PLANNING DIVISION STAFF REPORT

CASE NUMBER: **SD2026-0003**

APPLICATION: **Preliminary Plat – Bernal Landing Subdivision**

LOCATION: **7218 Airport Road, Nampa**
R30550012, 5.38 acres

DRAWING TITLE:
BERNAL LANDING
7218 AIRPORT ROAD
PRELIMINARY PLAT

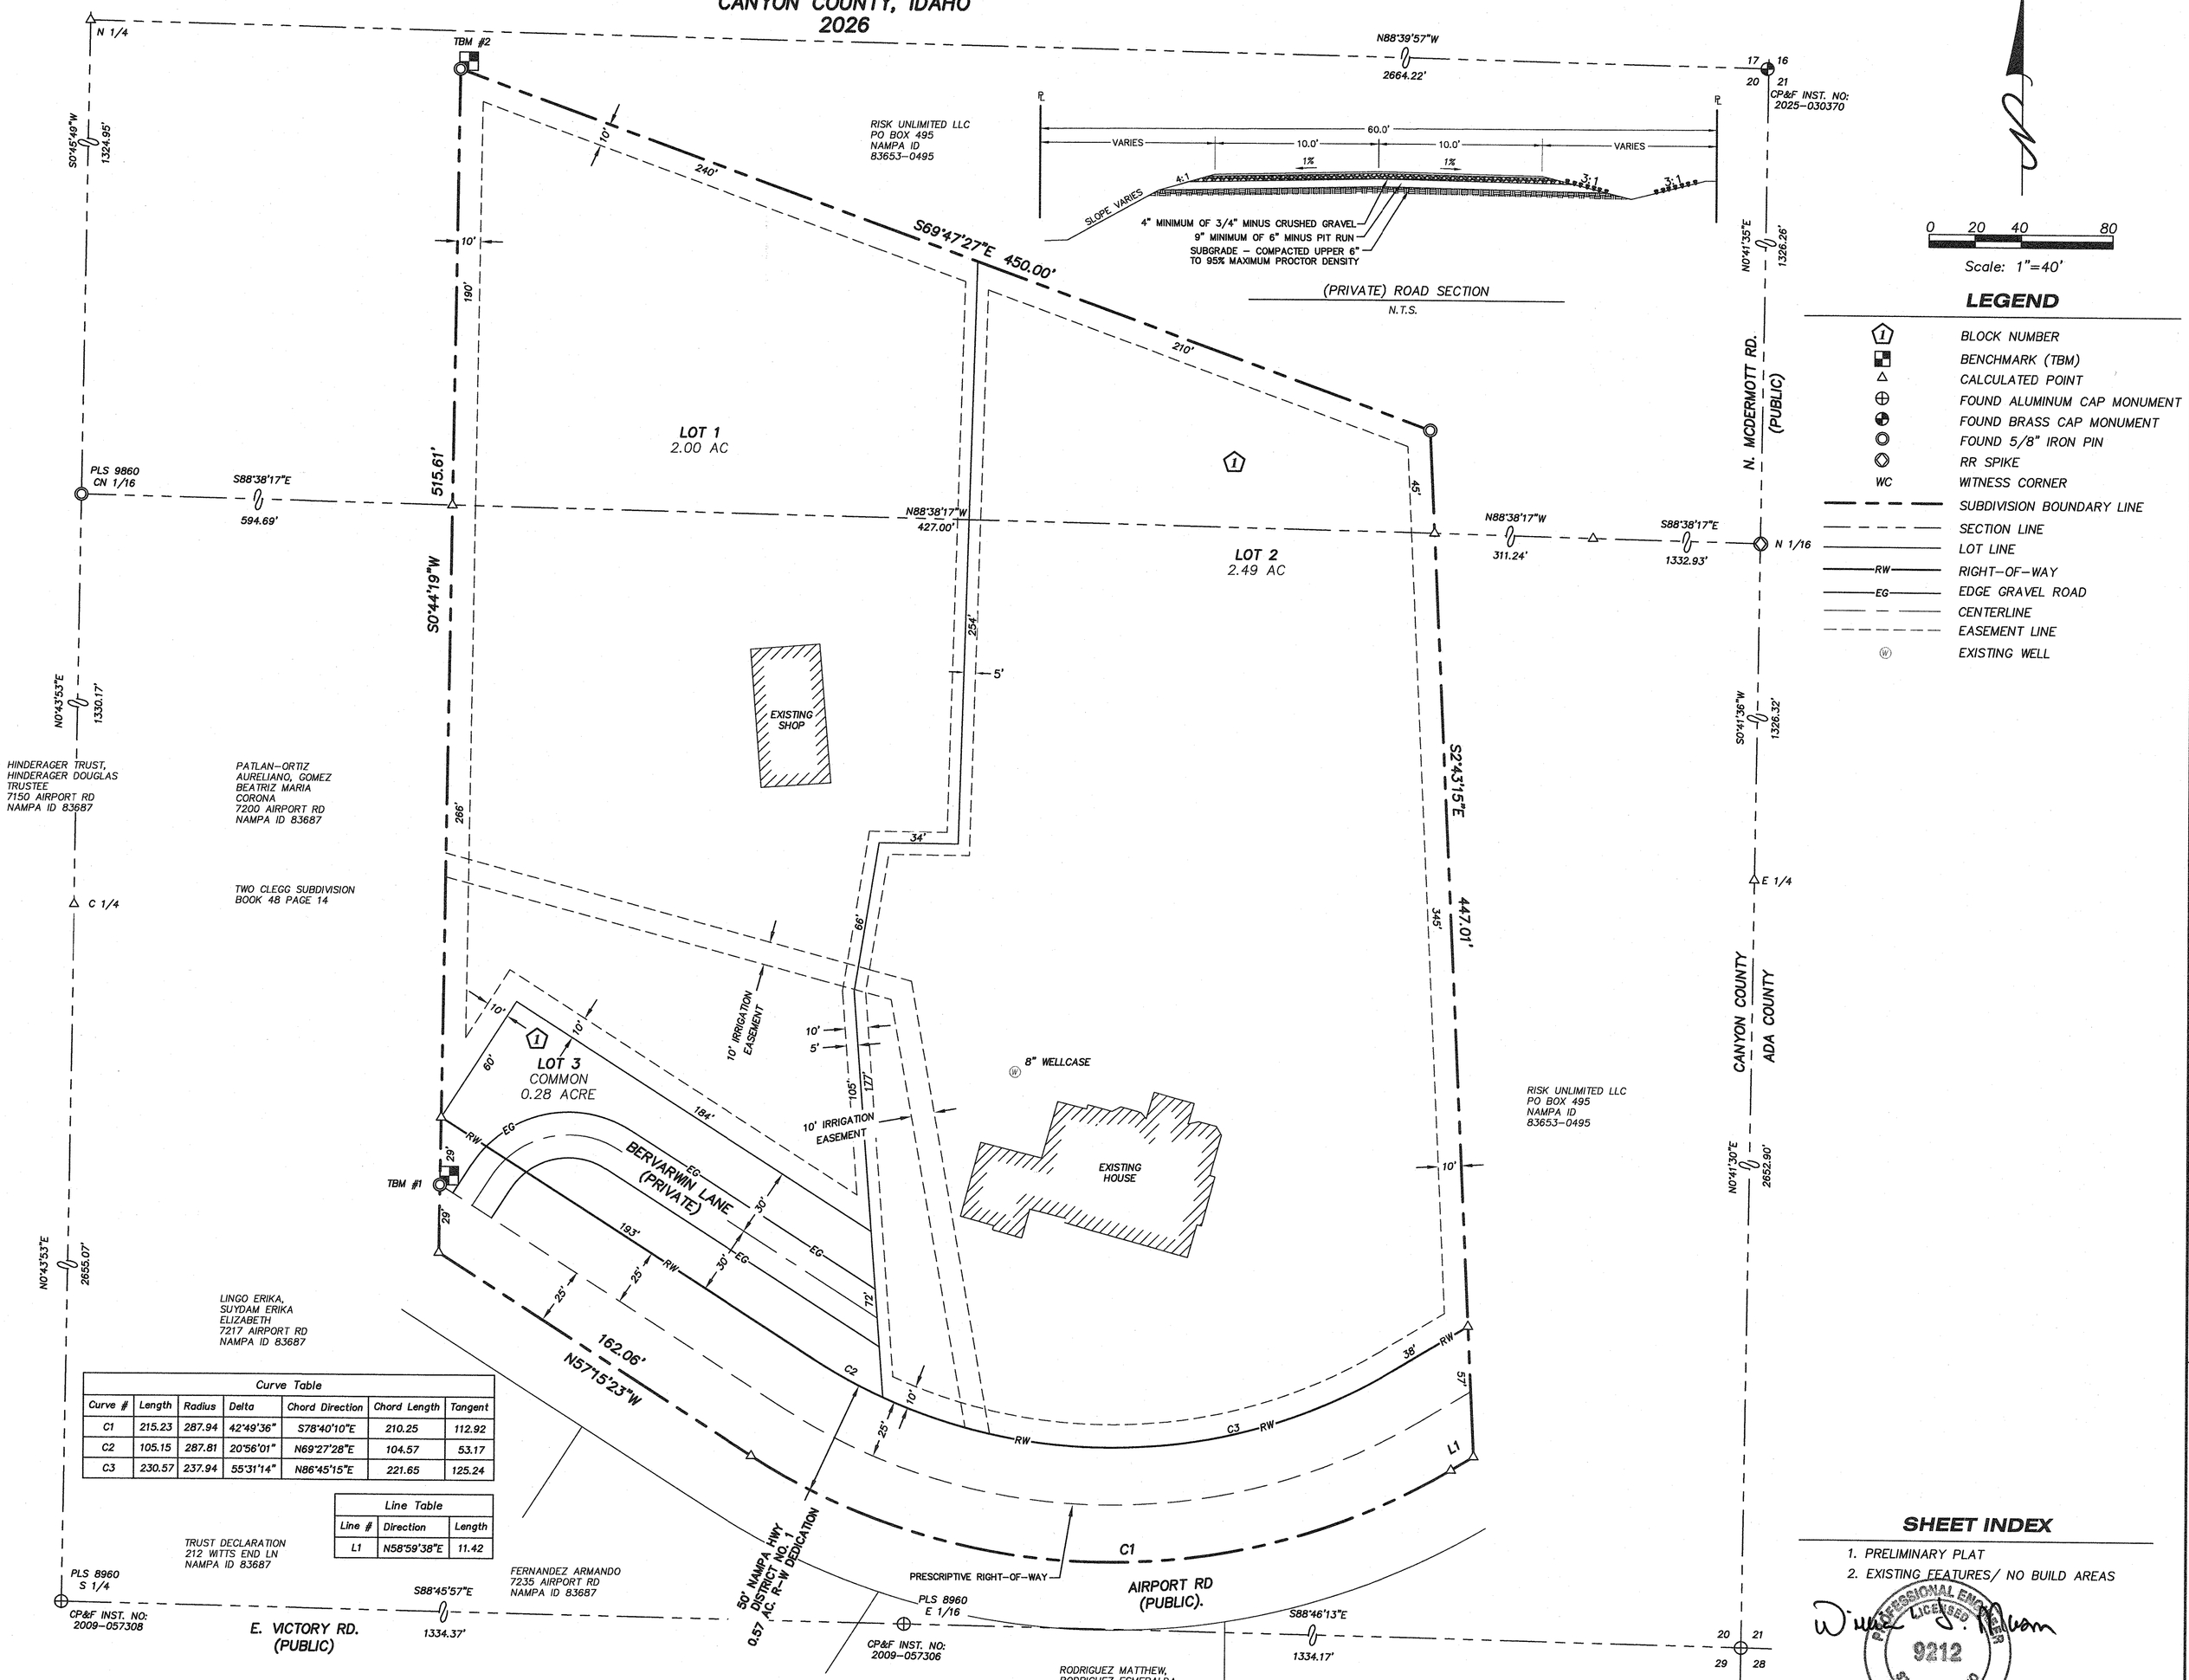
• Proposed name of the subdivision and its location by section, township, and range (CCZO 07-17-09(1)B.1).
Review Comment: Not compliant. Should be SW ¼, NE ¼, Section 20 | 2nd Rev: Compliant.

• The vicinity map is drawn to scale, clearly showing the proposed subdivision location in relationship to adjacent subdivisions, main arterial routes, collector streets, etc. (CCZO 07-17-09(1)B.8).
Review Comment: Not compliant. Vicinity map adjacent subdivisions Jaialdi Estates and Two Clegg Sub. | 2nd Rev: Compliant.

• All roads must be labeled as either "private" or "public" behind or beneath the road name (CCZO 07-17-09(1)D.8). Private roads must be in a road lot (CCZO 07-17-09(1)D.
Review Comment: Airport Road is missing the label "public". | 2nd Rev: Compliant.

• Missing C3 curve data. Provide revised plat.

1. The ingress/egress easement through Lot 1 to the back of Lot 2 has been removed.
2. A private road common lot has been added and the easement for it widened to 60'.
3. Curve C3 dimensions have been added to the curve table.
4. Utility and irrigation easements have been clearly dimensioned and marked.
5. Lot count in the project narrative has been updated.

DRAWING TITLE:
BERNAL LANDING
7218 AIRPORT ROAD
EXISTING FEATURES/NO BUILD AREAS

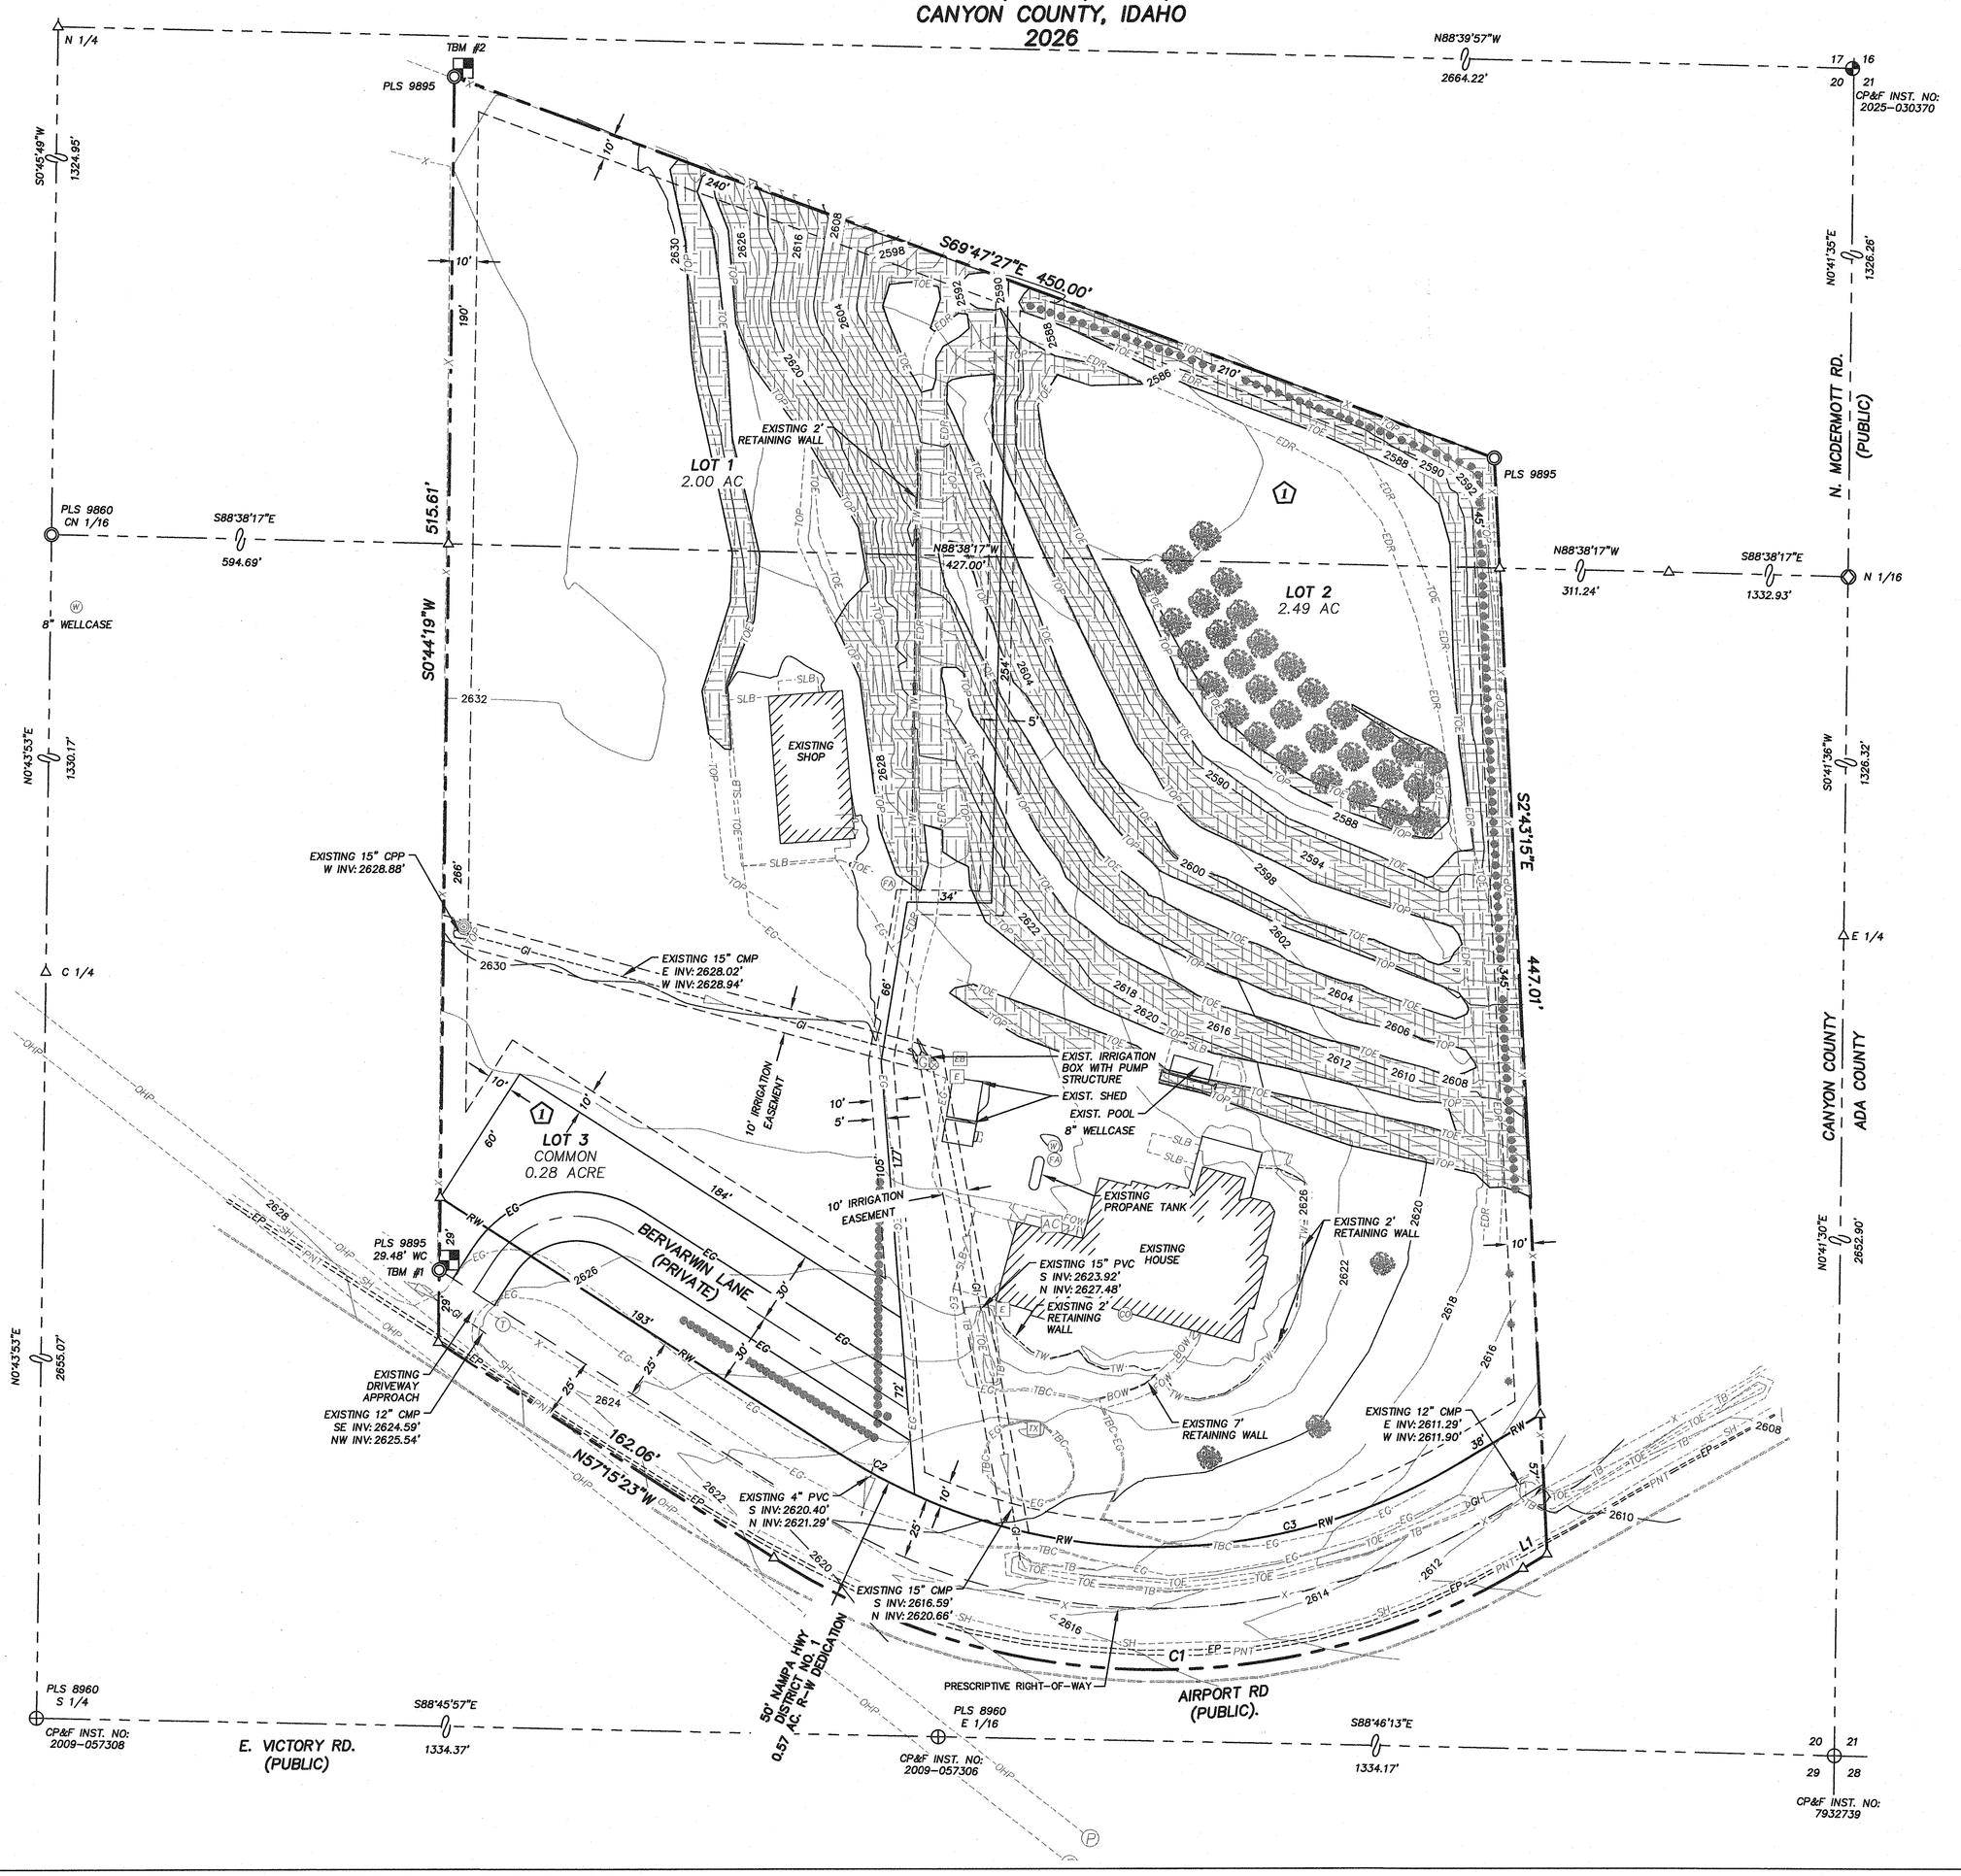
2nd review: Compliant. The preliminary plat (Sheet 2) includes crosshatch shading to designate non-buildable areas with slopes of 15% on the northern/eastern portion of the property.
